Attn: Hector Terminal Expansion & Renovation – Bid Pack #4

Subject: Bidder Questions

Bid Package #4 Questions

3 SECURE LINE POST TO EXISTING CONCRETE DETAIL

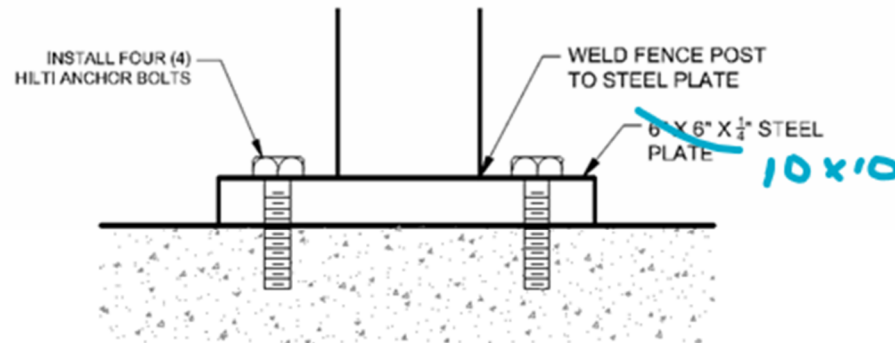
- a. Silicone is required.
4. The permanent fence drawing on sheet C-601 has a note that says "Proposed security fence shall be secured to the existing apron pavement when within the apron area. Fencing beyond the apron limits will follow detail 1/C-601)". If I'm not mistaken, much of the fence to be installed would be considered "within the apron area" (at least 320 LF). Do you have a spec or drawing that depicts exactly how the fence should be secured to the existing apron pavement, as to meet airport standards?

- a. The detail in the plans should be modified to a 10" x 10" x 1/4" steel plate as shown below
